UNC Charlotte Phase 16

Addendum #4

Revision Narrative

2021-09-08

E-201S

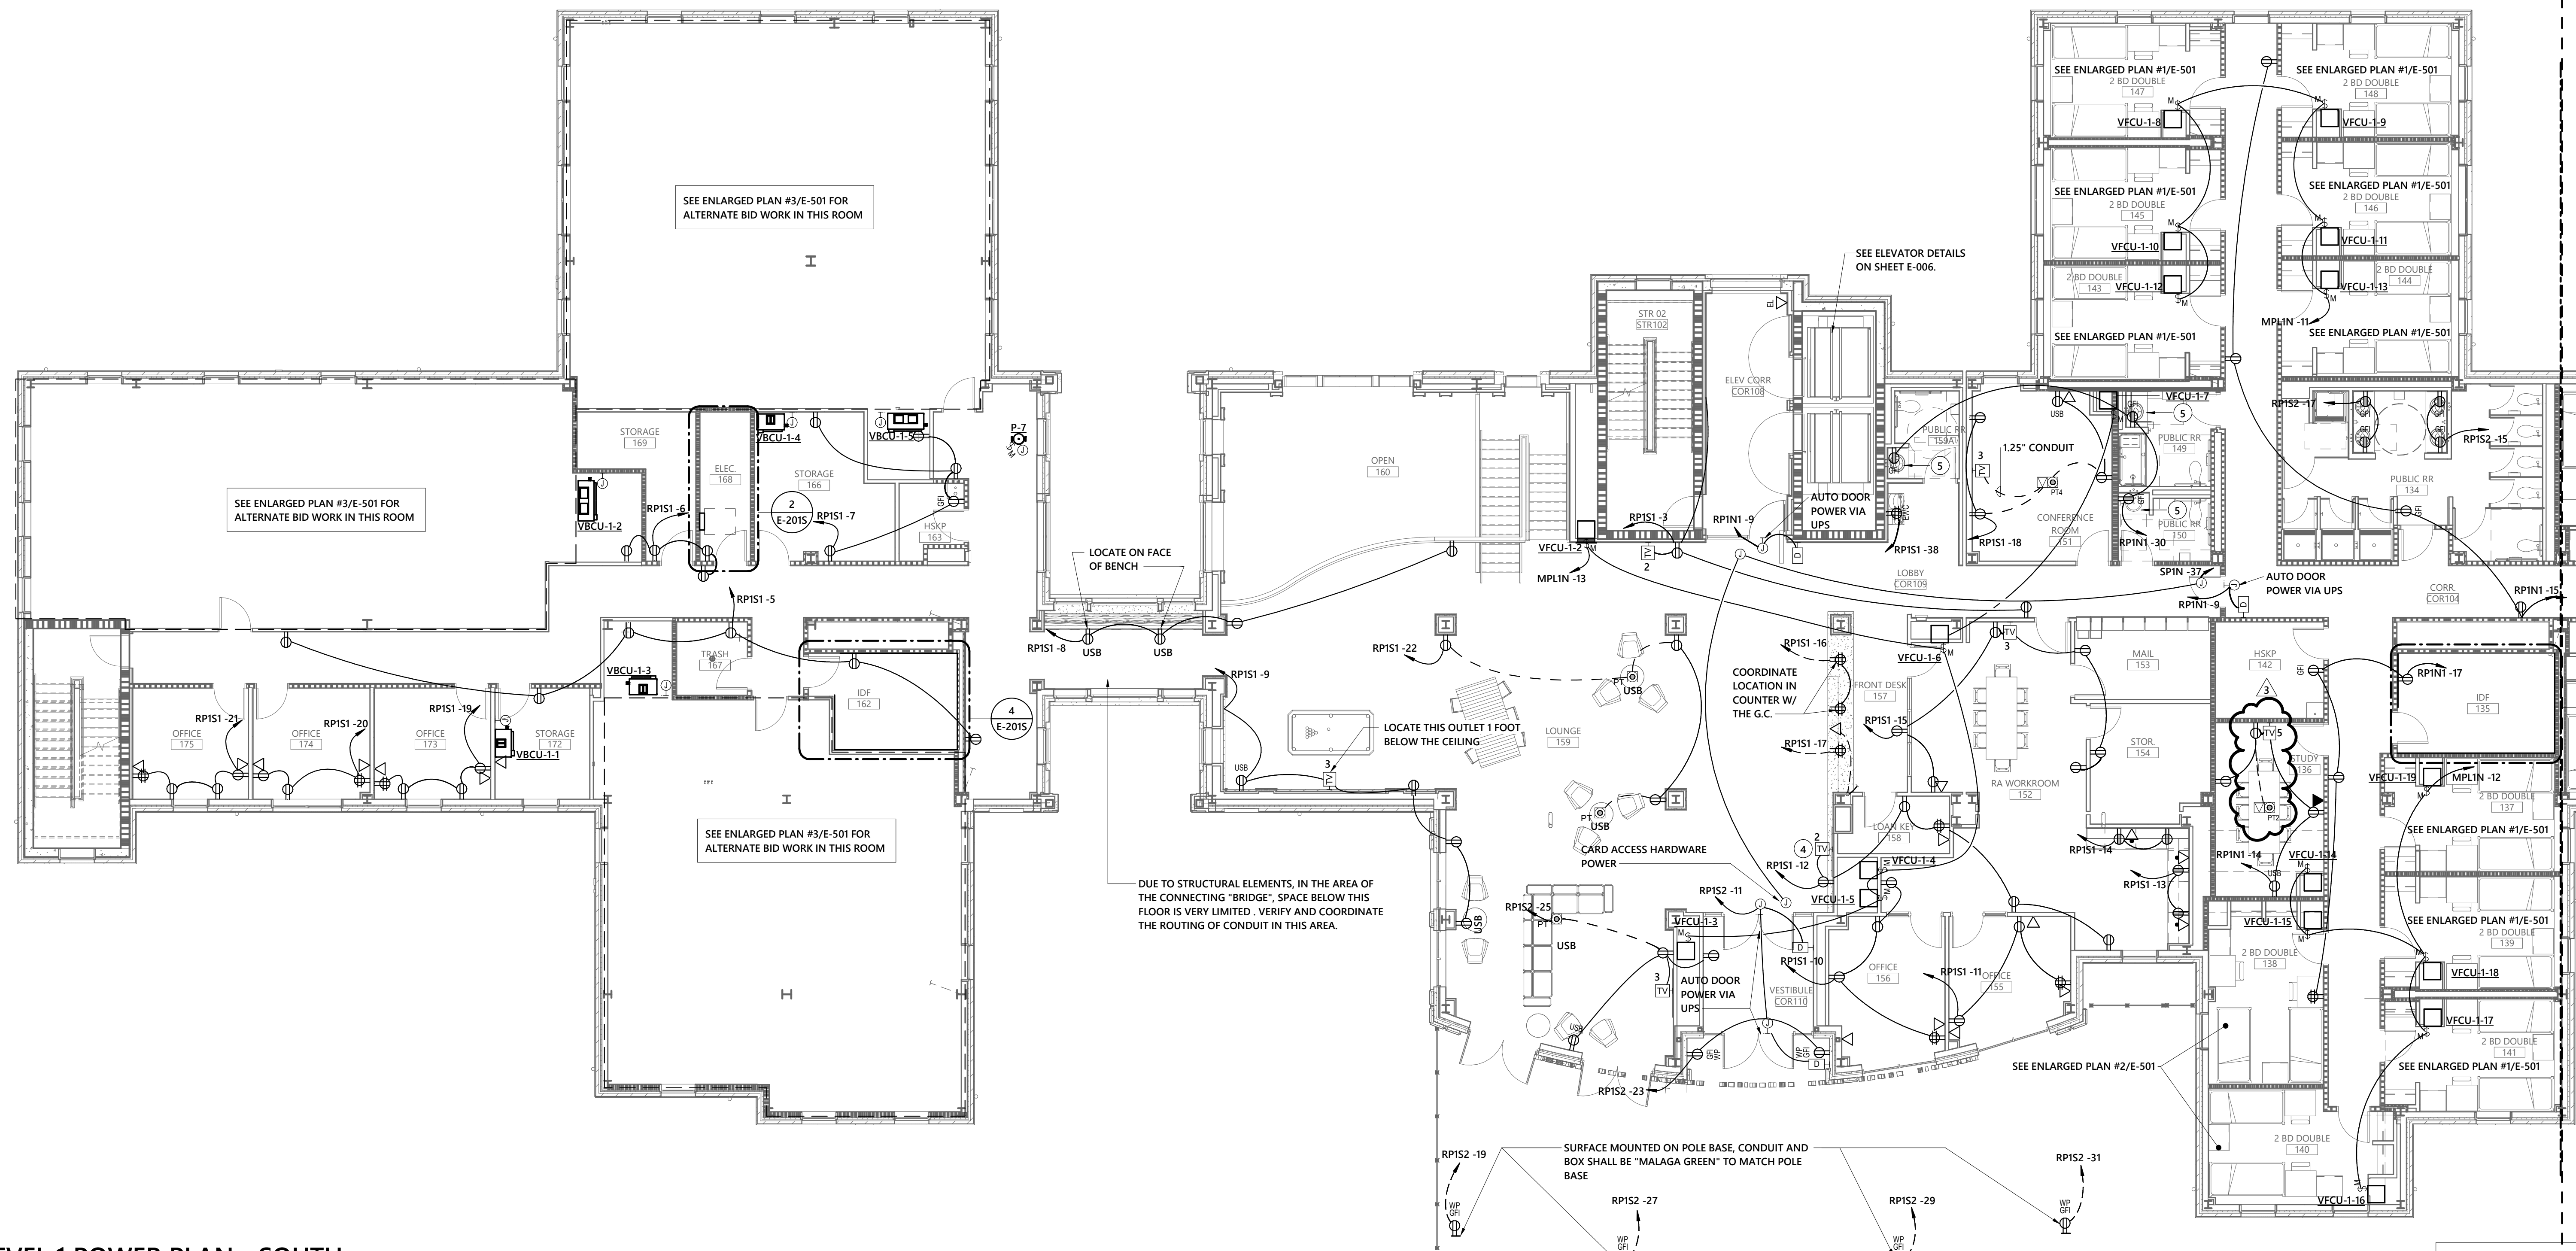
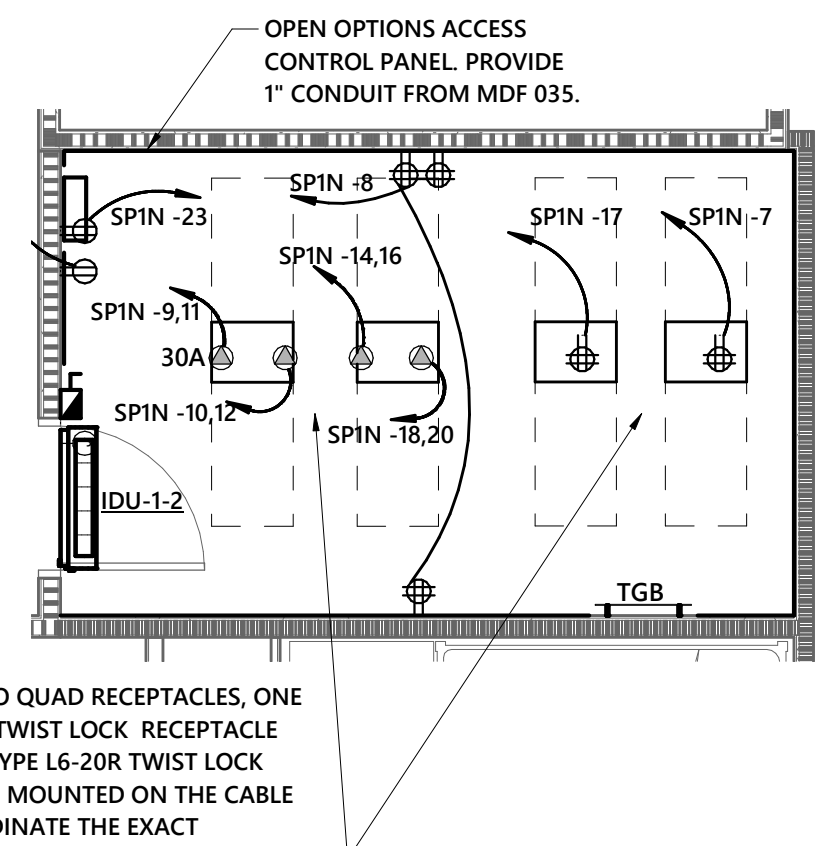
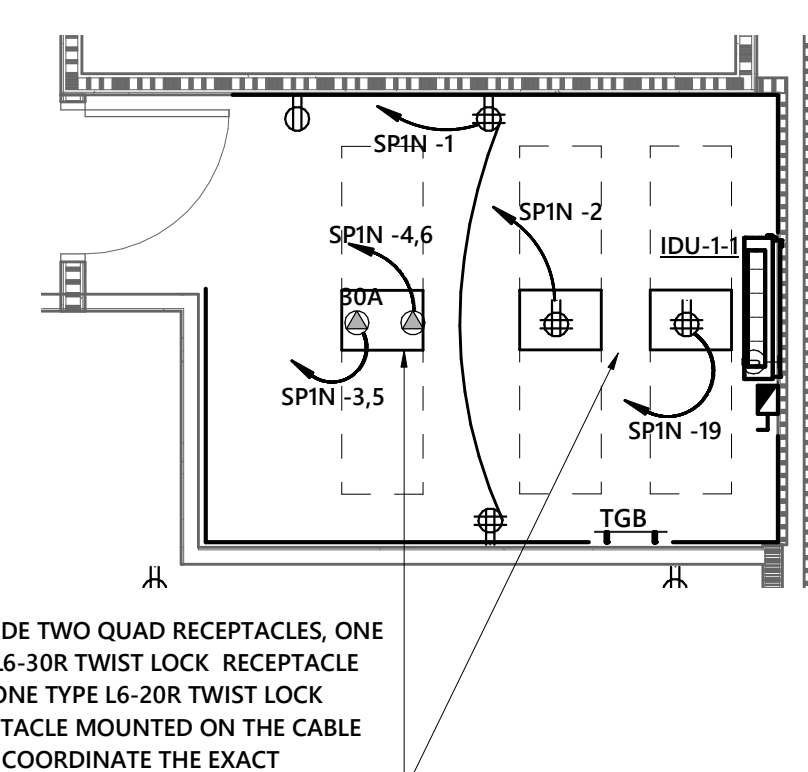
E-201S - added Pokethru, TV detail updated.

E-202N

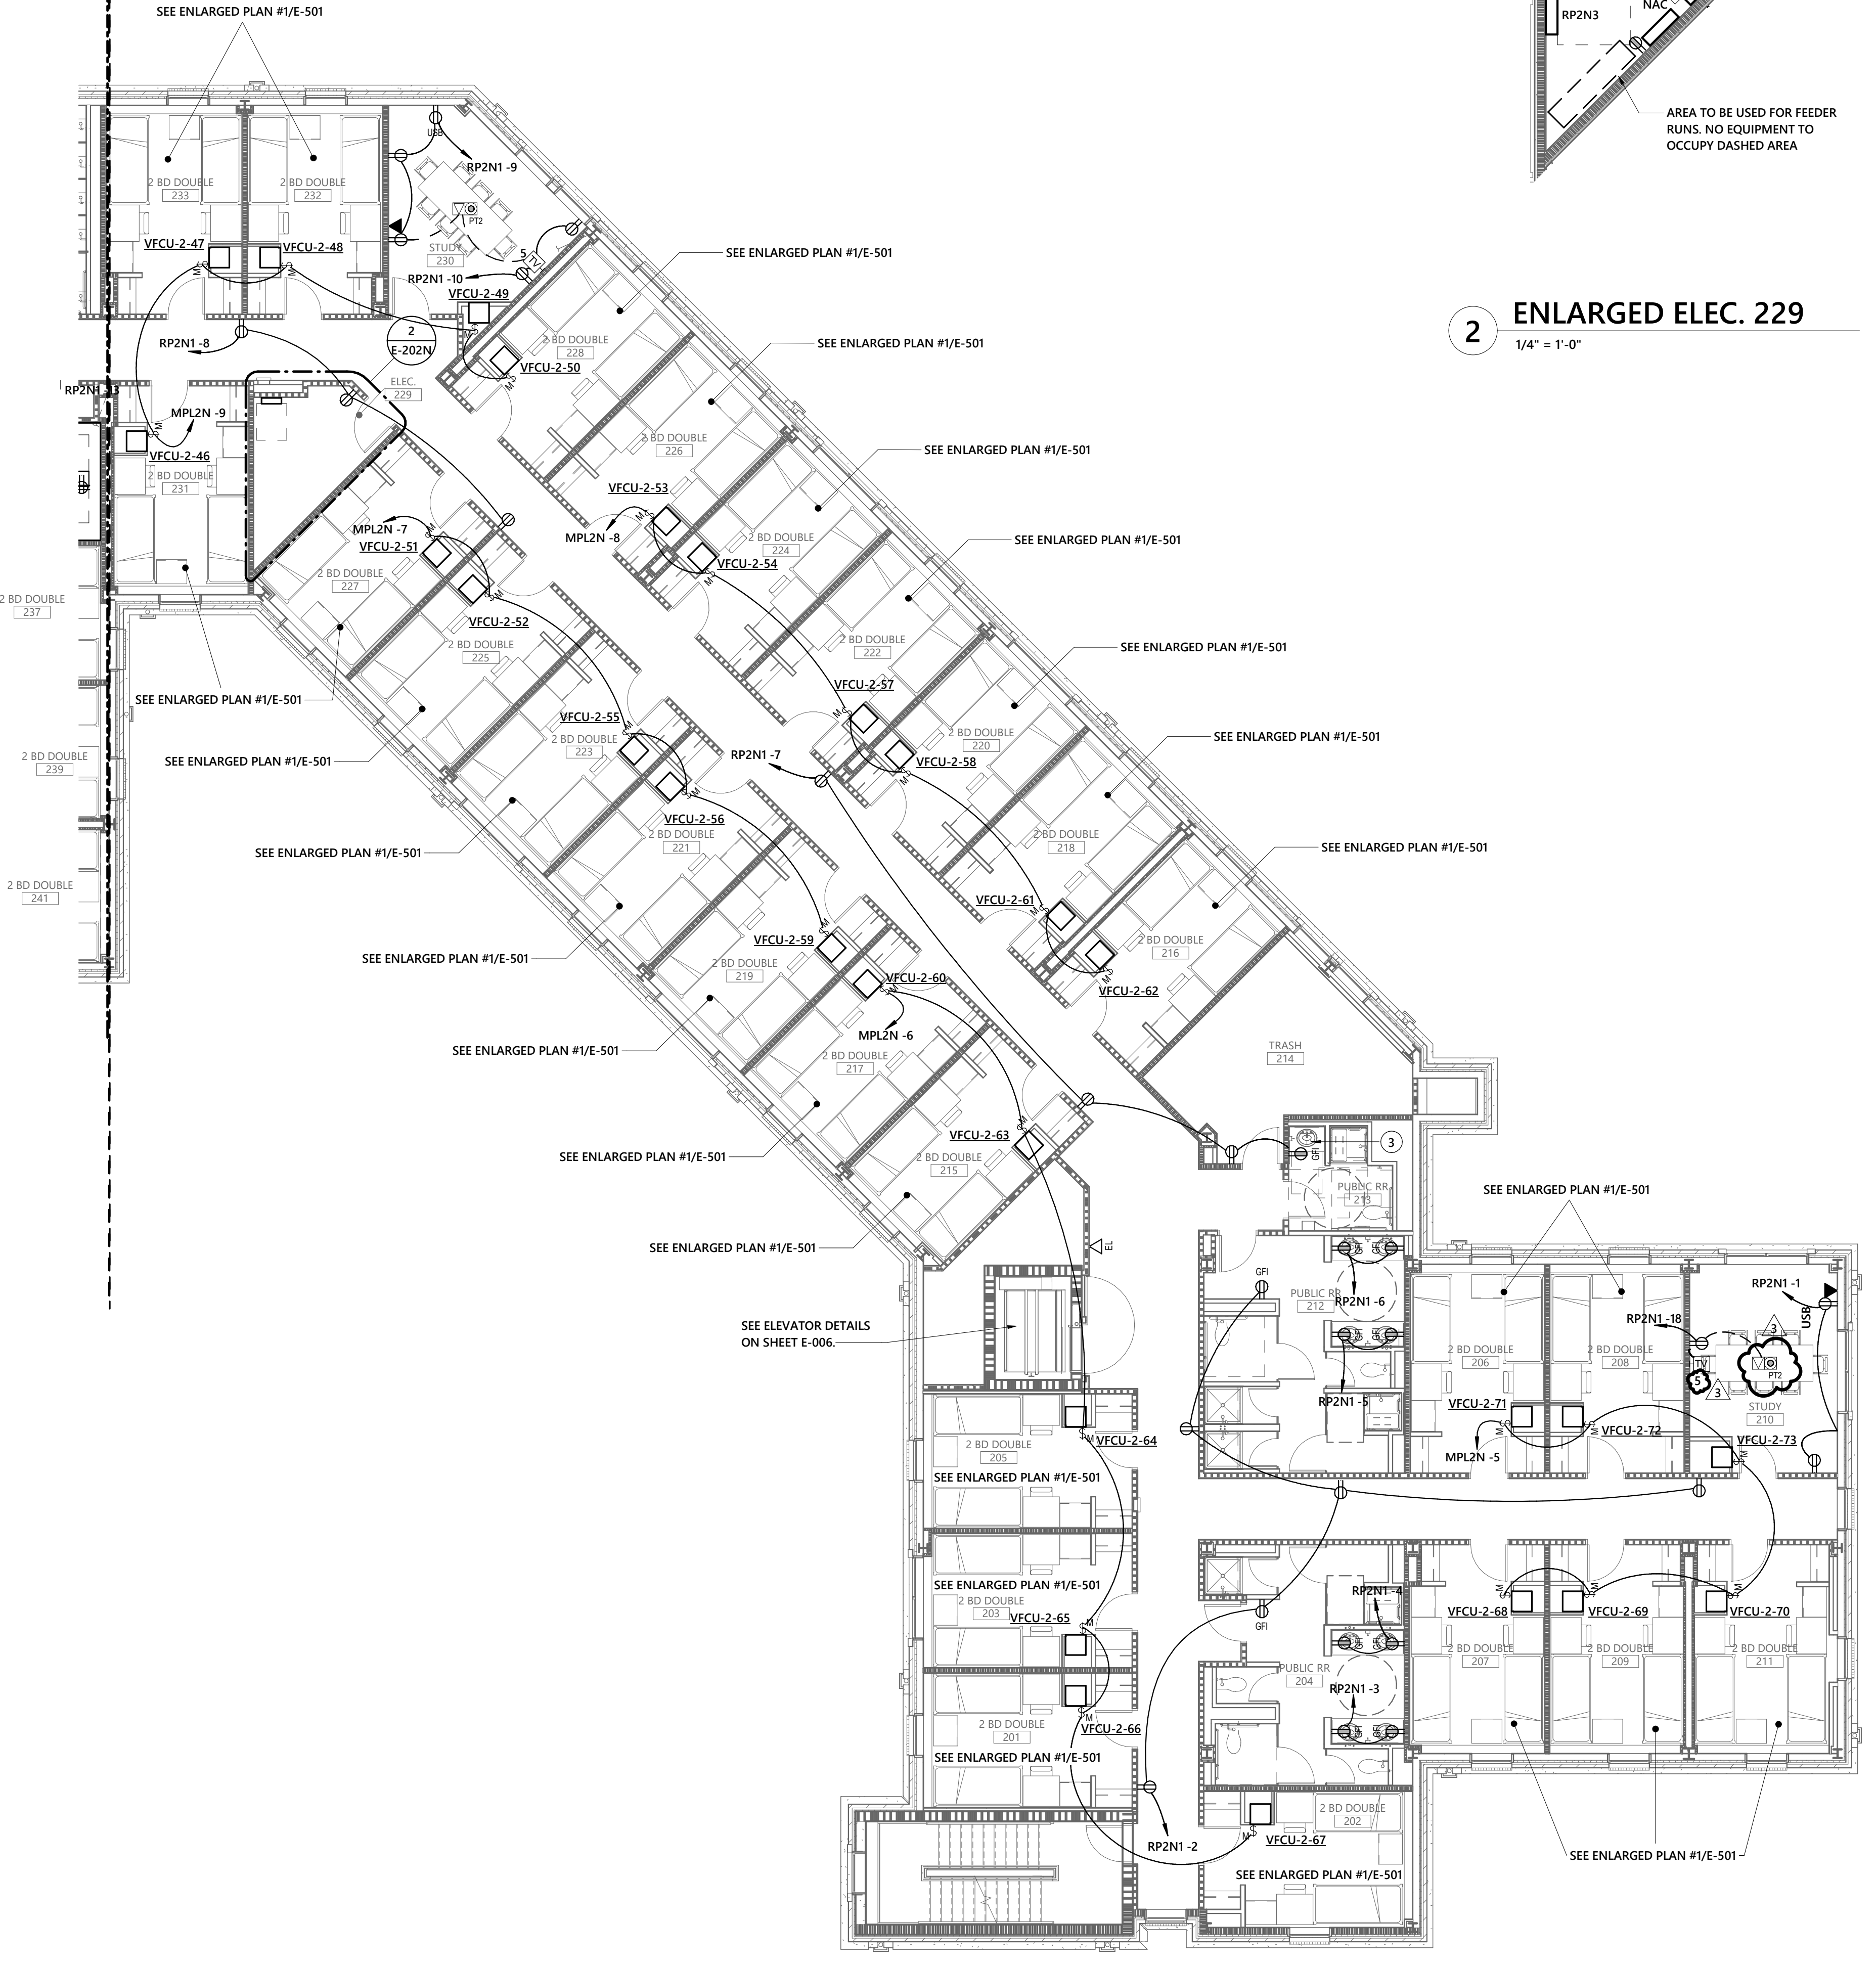
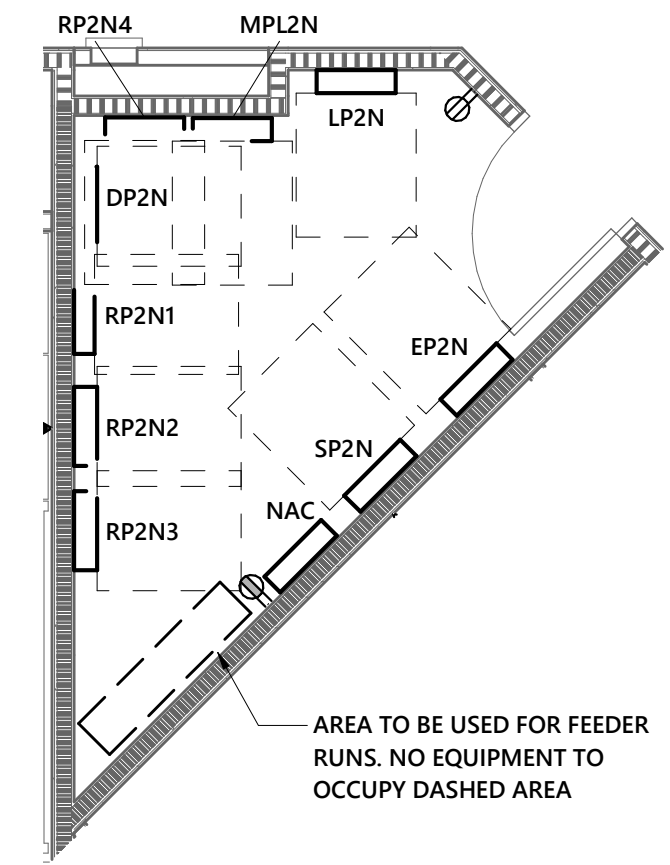
E-202N - Changed TV type. Poke thru type changed.
